**CLEVELAND HOPKINS
INTERNATIONAL AIRPORT
CLEVELAND, OHIO**

Project Title RTA TUNNEL MEMBRANE REPLACEMENT			
Sheet Title SHEET INDEX AND SUMMARY OF QUANTITIES			
Designed: MSI	Drawn: MSI	Checked: LGW	Approved: LGW
Scale: AS SHOWN		Project No.: 198348	
Date: FEBRUARY 2024		Sheet: C-2

2/26/2024 Prebid Questions:

MOT PHASE 2 PLAN
SCALE: 1" = 50'

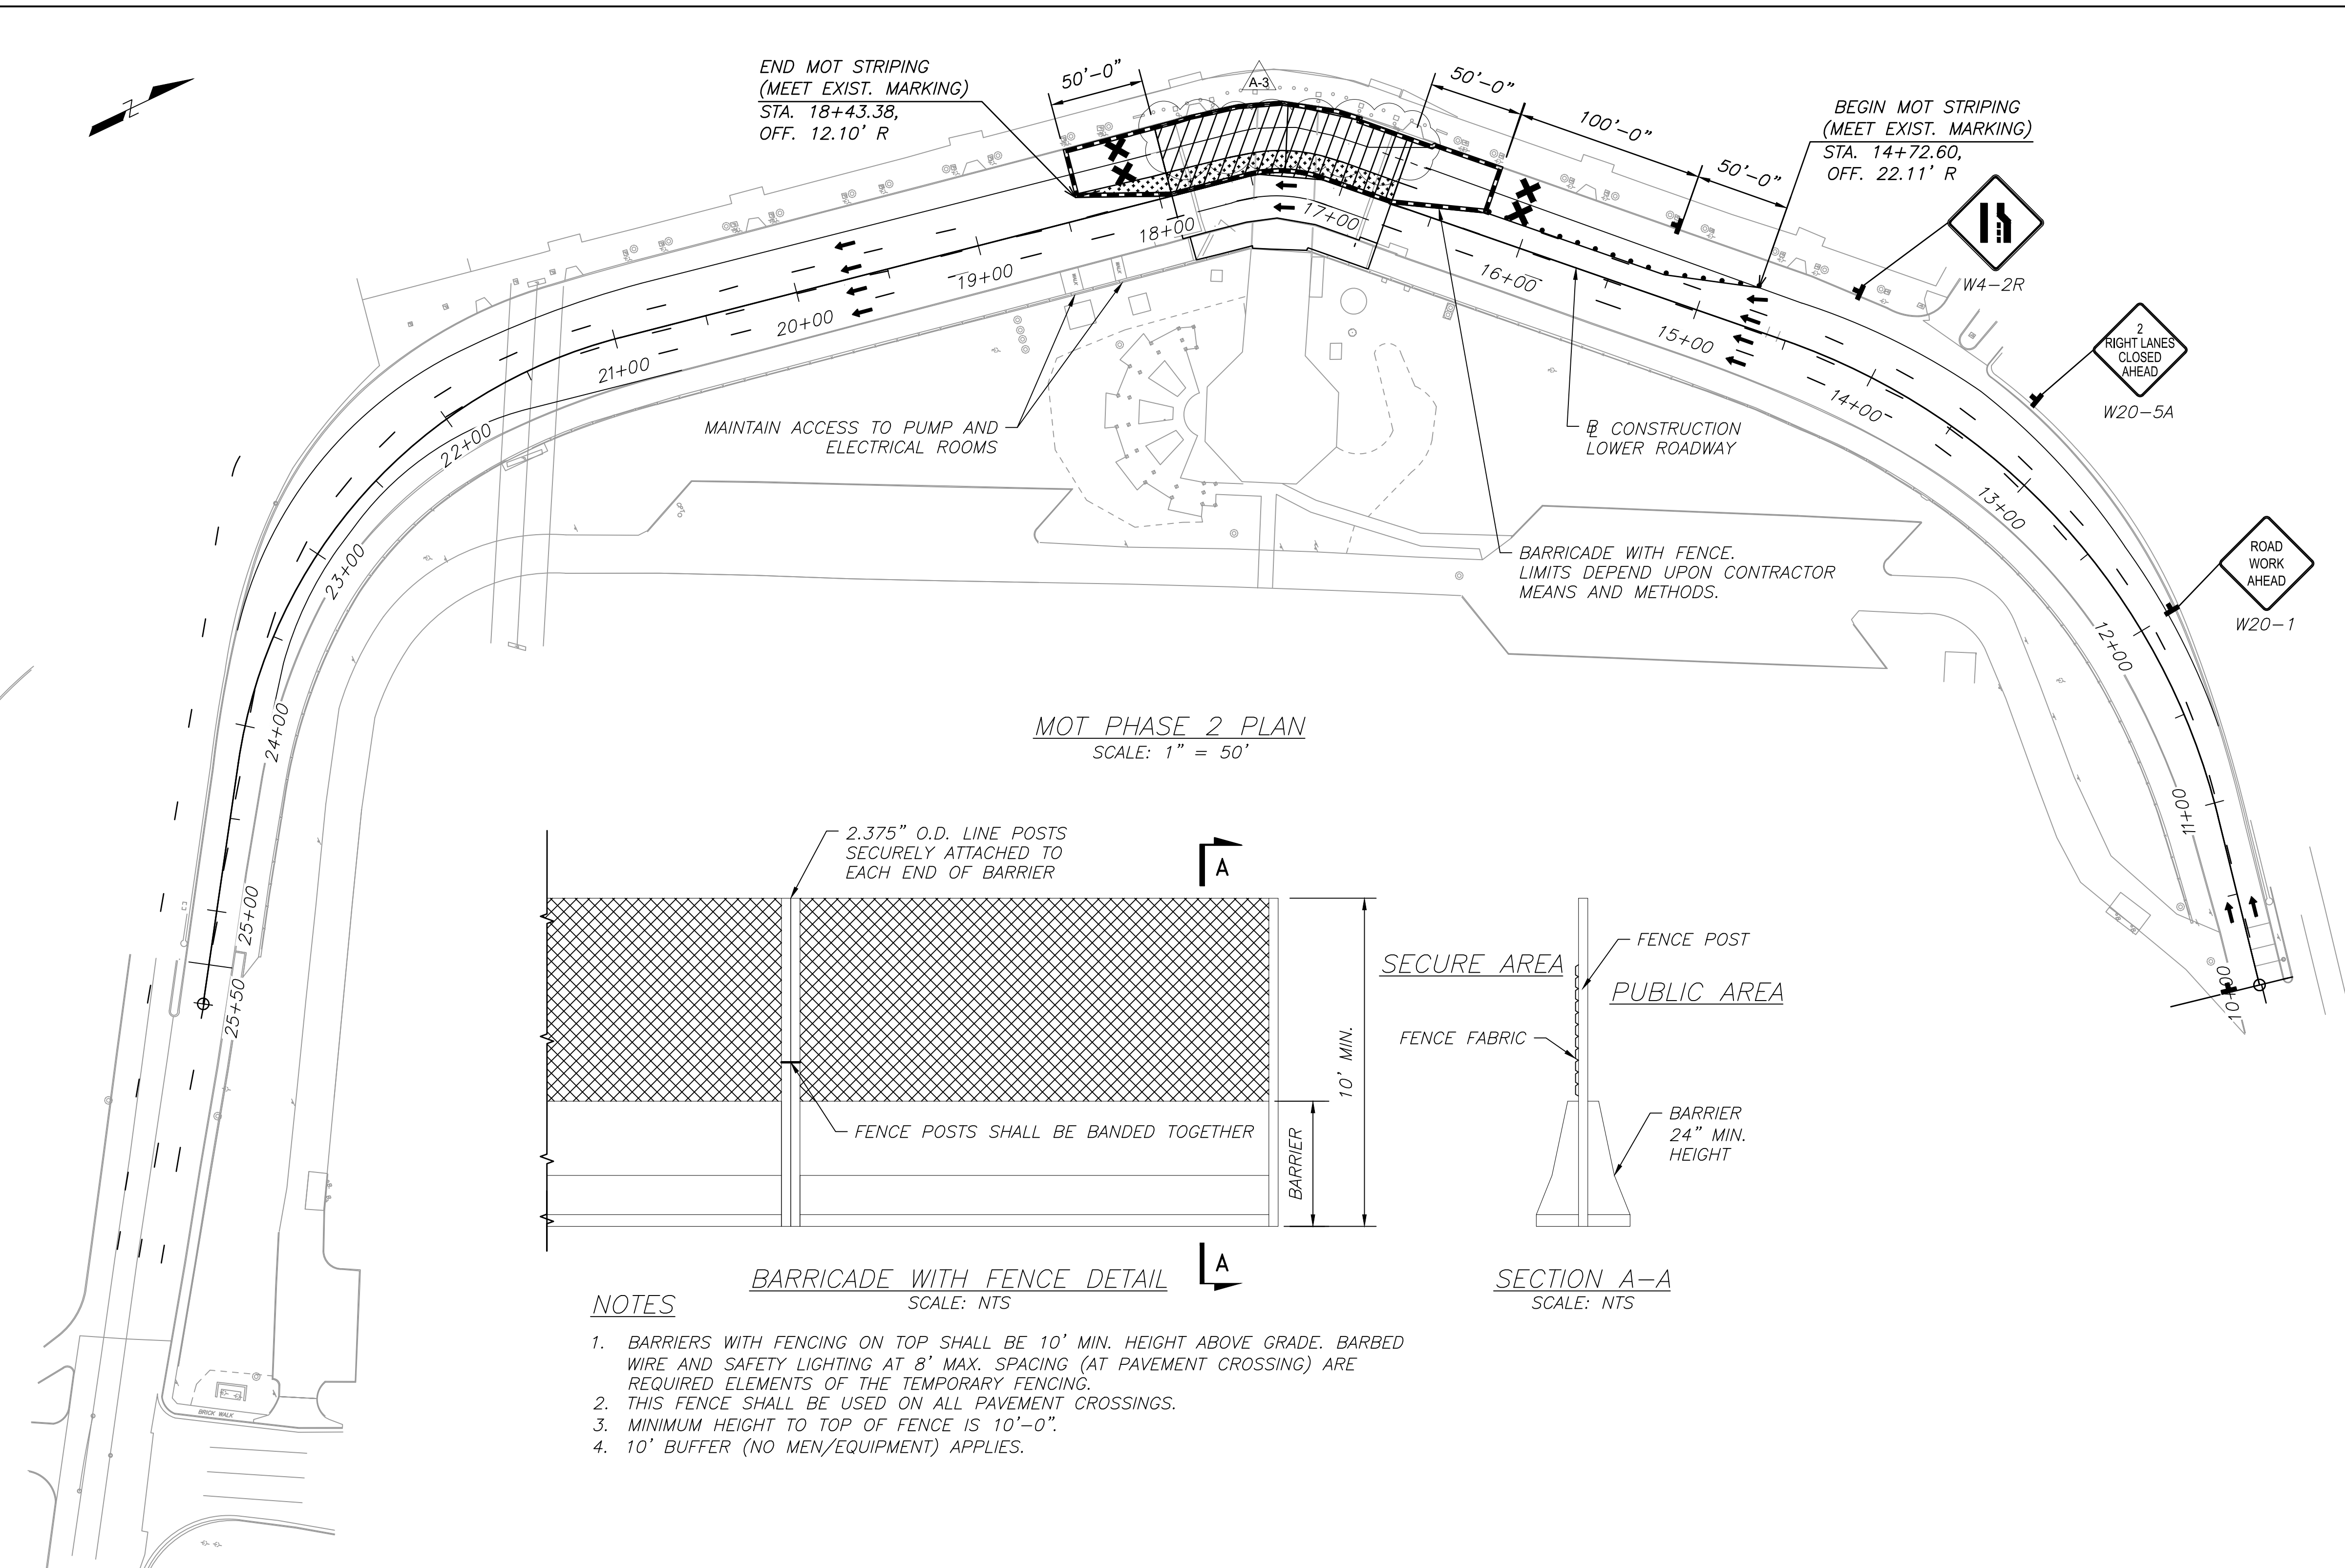
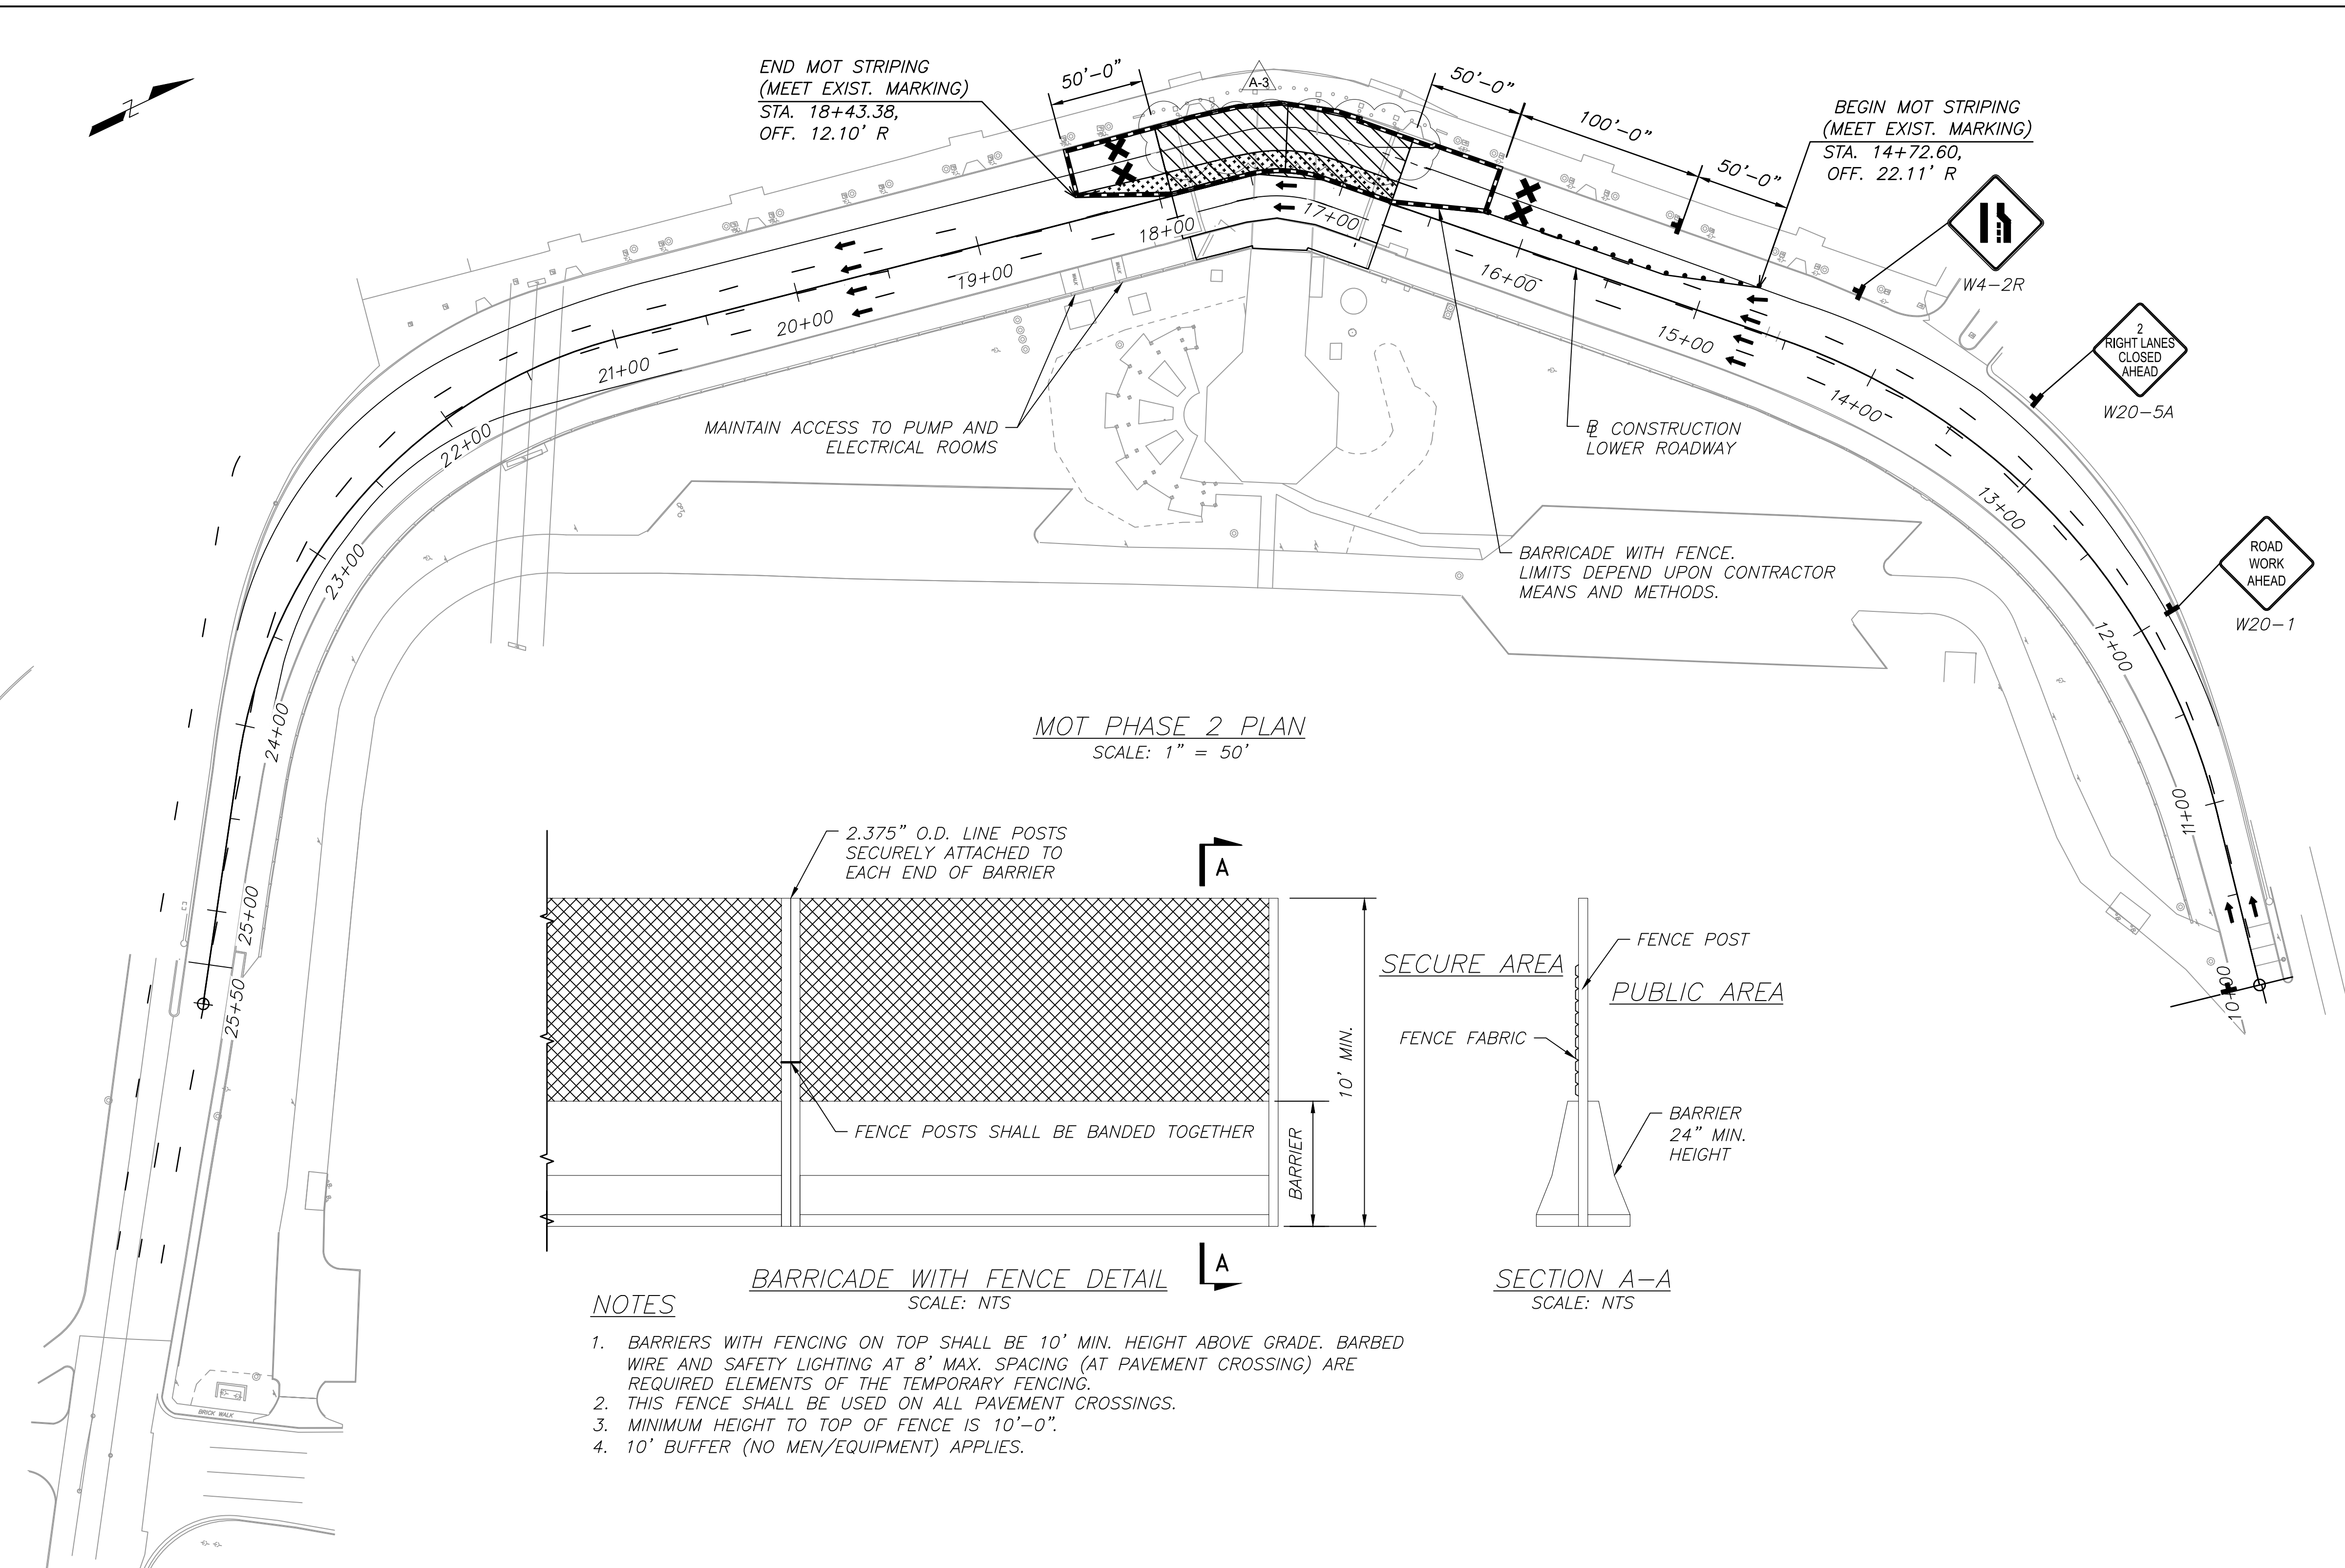
Question: The Maintenance Of Traffic plans for Phases 1 thru 4 show the use of drums at 10' C/C, to provide a 2'-0" buffer between the work zone and travel lanes. The work zone areas will have a drop off adjacent to the travel lanes. Should the maintenance of traffic plans be revised to include barrier protection for the work areas?

Question: Will any of the Phases of construction require chain link fencing to separate the work areas from the Terminal? If so, please specify the locations.

Question: Plan Sheet C-20 provides cross sections "parallel to the roadway" to excavate for the replacement of the footer drain, but does not provide dimensions and/or elevations from the top of pavement to the top of the existing footers. Also, there are no cross section views of the excavation transverse to the roadway to show how this work will be performed in Phases 1 thru 3. Please have the Engineer of Record specify how the excavation for footer drain replacement can be performed adjacent to the existing travel lanes that are to be maintained, that are separated by only 2'-0" from the work areas?

Answer: Please see the revised MOT Drawings.

Answer: Please see revised MOT Drawings.

Answer: Please see revised Maintenance of Traffic Drawings. There will be approximately 10' of the road that will be closed in bot Phase 1 and Phase 2. It is anticipated that the required shoring/bracing will be installed in the 10' +/- buffer.
